P.O.A.D.P. OF

T. & D. MORAVITS SUBDIVISION

INFORMATION SHEET FOR
PRELIMINARY OVERALL AREA DEVELOPMENT PLAN
(P.O.A.D.P.)

FILE NO. 85-23-54-40
(To be assigned by the Planning Dept.)

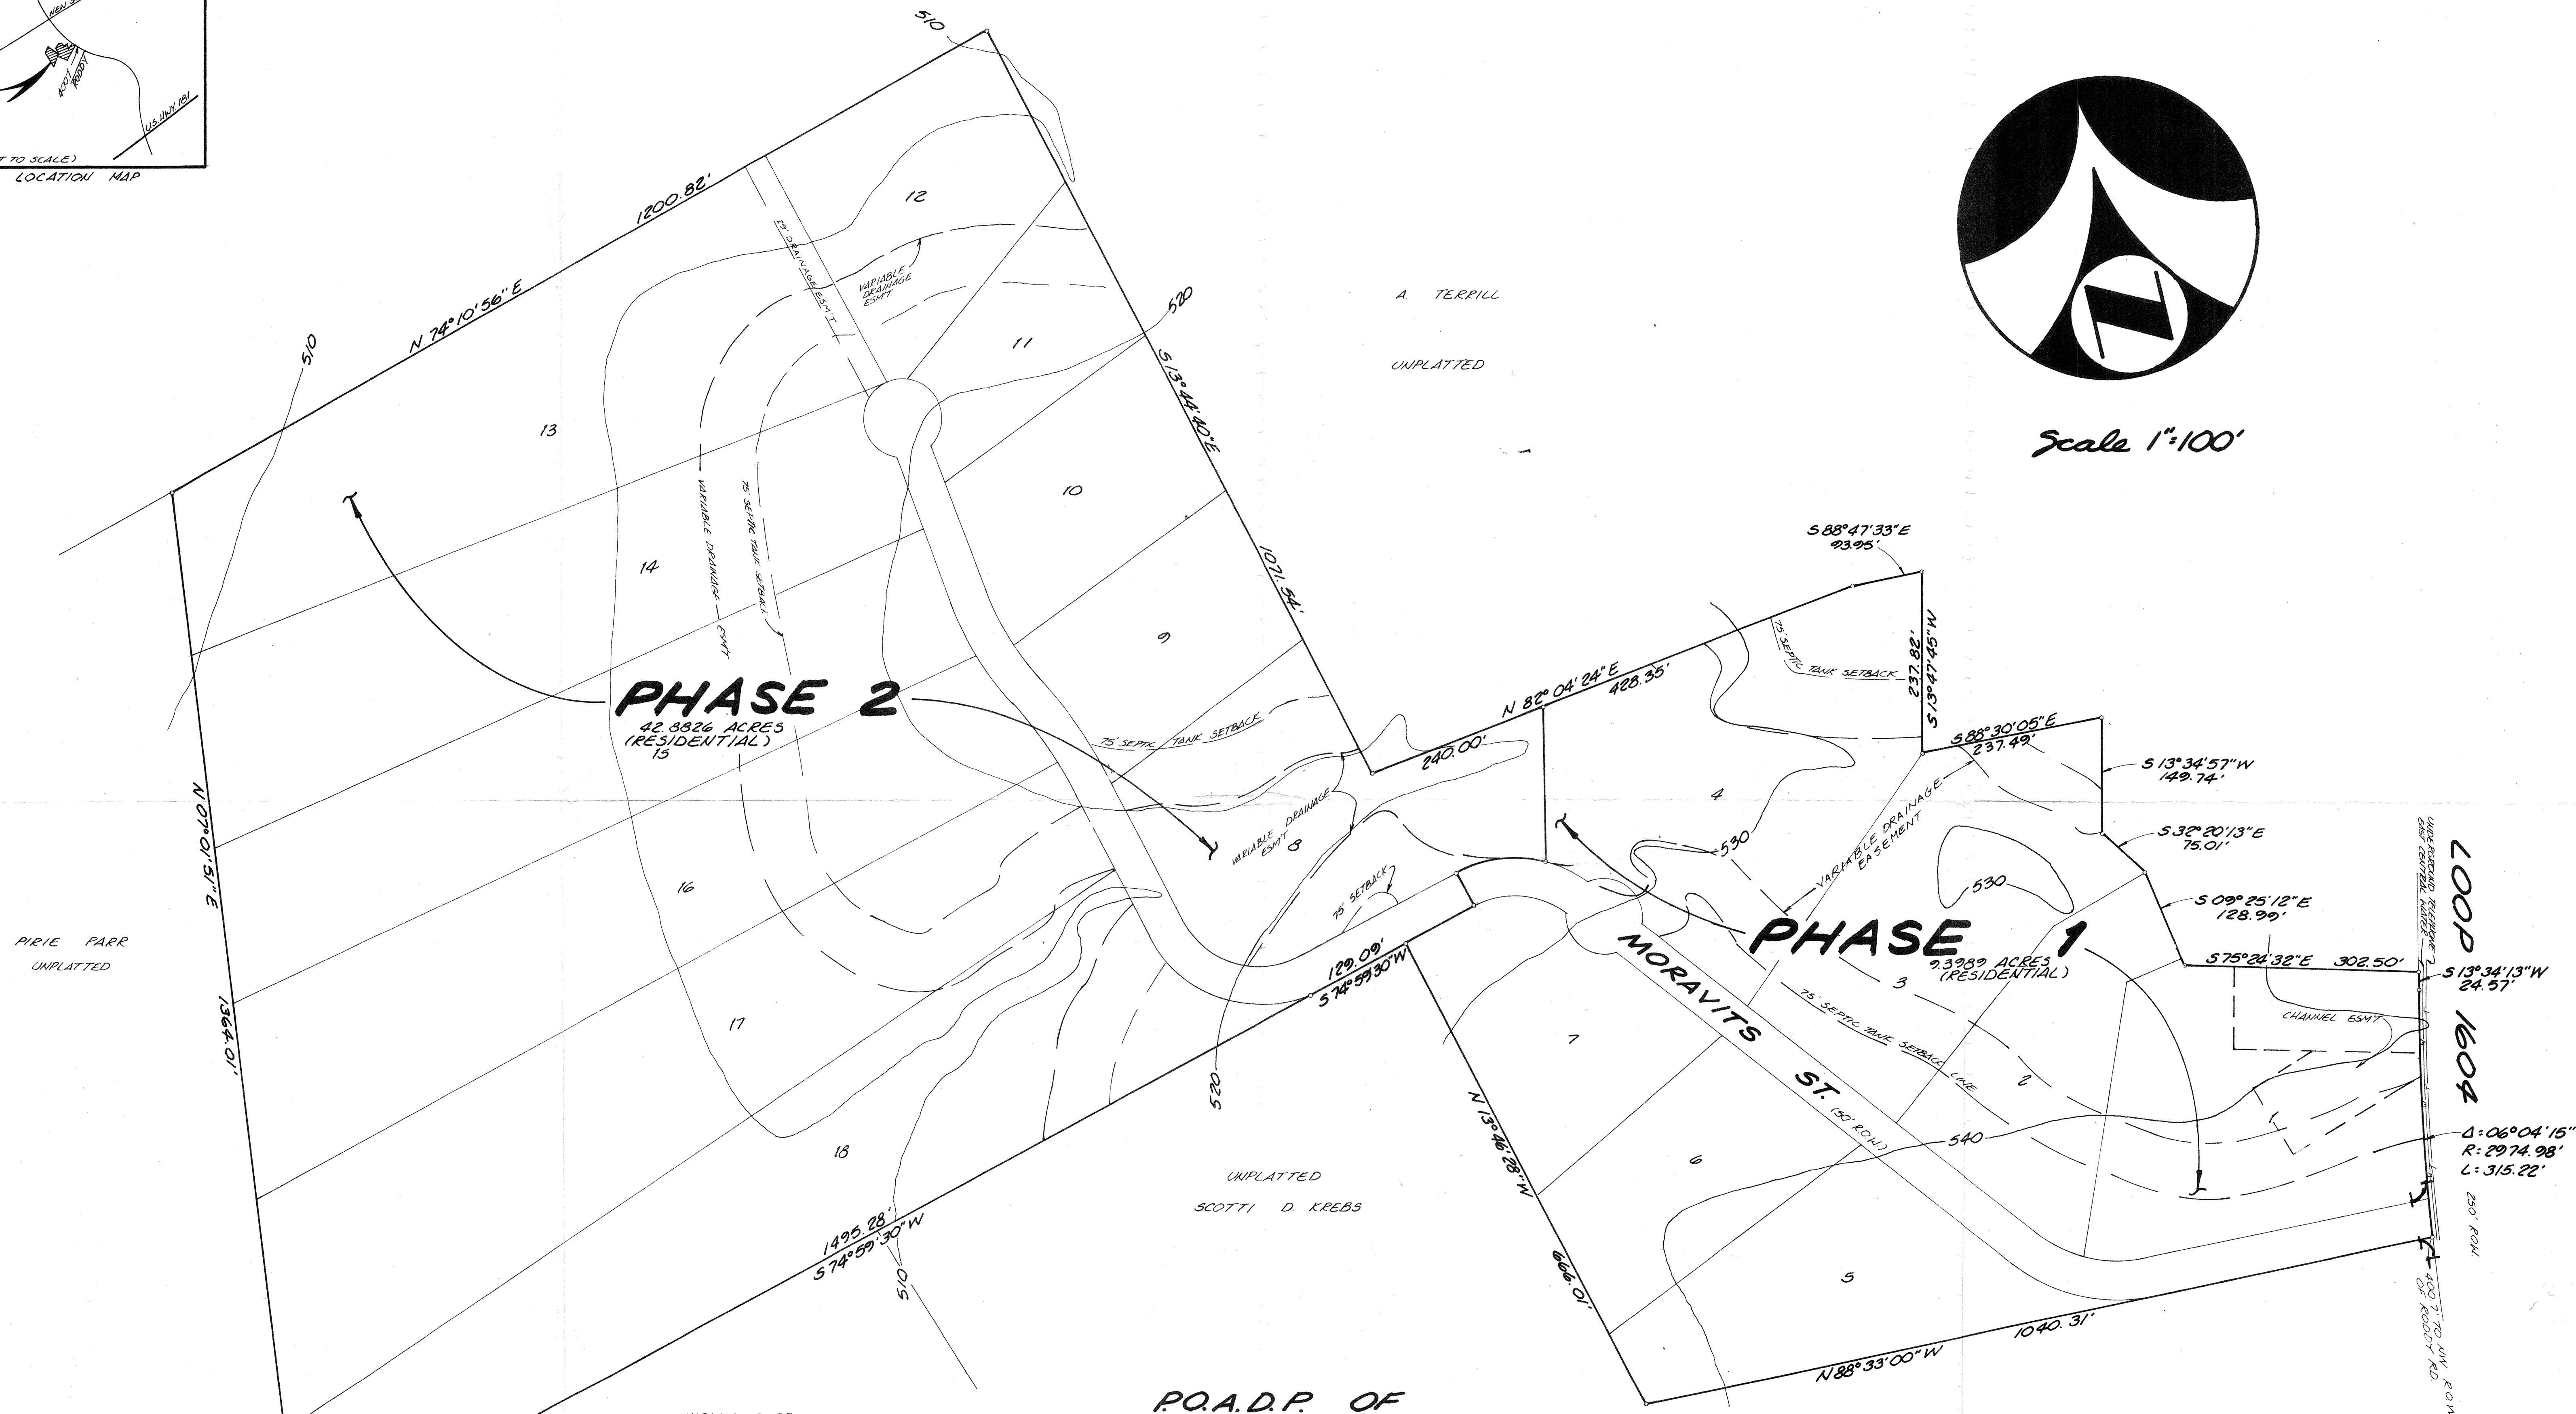
COMMENTS: Committee reviewed plan 1-11-85. Cul de sac length
was addressed and it was recommended that
an additional turnaround be provided

| <input checked="" type="checkbox"/> Cul-de-sac streets in excess of 500' | _____ |

With regard to the 2550 foot cul de sac length it is recommended that an additional turn around be provided. The preferred location is between the street terminus and FM 1604.

If you concur, please resubmit the plan with the necessary revision. However, if you believe this matter needs further discussion, the staff will be available to meet with you.
